R08NC

September 18, 2008

Blue Bird Body Company has decided that certain 2004 through 2009 model year Blue Bird All American and conventional school buses manufactured from March 06, 2003 through March 28, 2008 fail to conform to Federal Motor Vehicle Safety Standard No. 221, (School Bus Body Joint Strength).

**RECALL R08NC
INSPECTION SHEET**

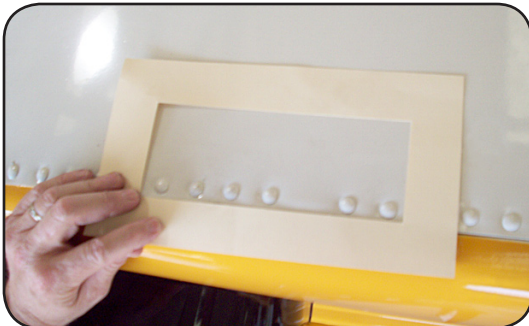
On some units, the rivet spacing may be incorrect in some segments of the rear roof sheet and rear roof cap joint, resulting in noncompliance with FMVSS 221, School Bus Body Joint Strength.

Inspect the rivet spacing at the joint and install additional rivets as required by specification.

2 Inspect rivet spacing at rear roof sheet and rear roof cap joint. Joint must have a minimum of six rivets in an eight inch segment.

2.1 Place the template over the joint and parallel to the edge of the roof sheet, allowing roof rivets to be exposed through the opening in the template as shown.

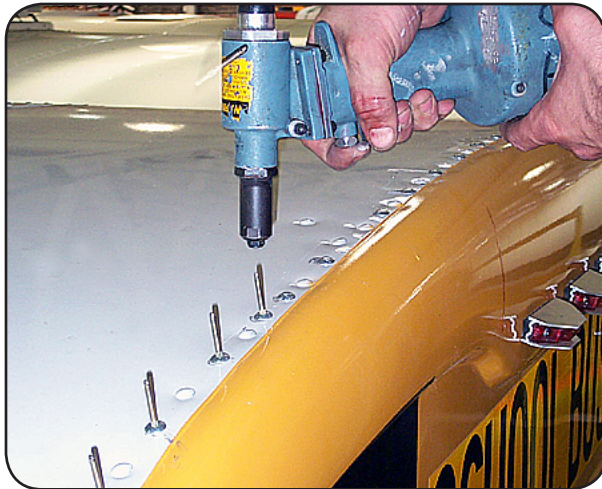
3 Install rivet/s at each mark. Using a short 17/64" drill bit, drill a hole through the roof cap, roof sheet, and rear bow flange. Be sure to drill hole on a common centerline with existing rivets.

4 Place a small amount of Vinyl Gray 5522 Sealant (Blue Bird # 0898627) in each drilled hole.

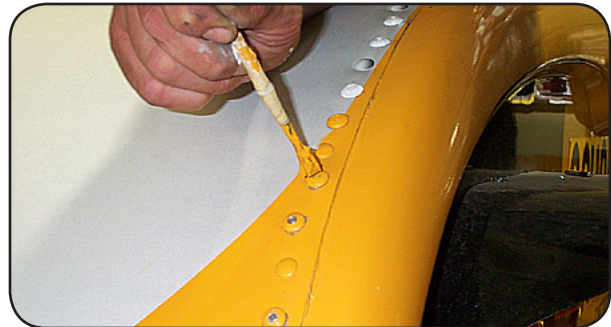
5 The supplied 1/4" blind rivets (Blue Bird # 1854397) are pre-painted white or school bus chrome yellow. Install a rivet of the appropriate color into each hole.

7 With the correct color paint, touch up the center of each blind rivet where the stem was removed during installation.
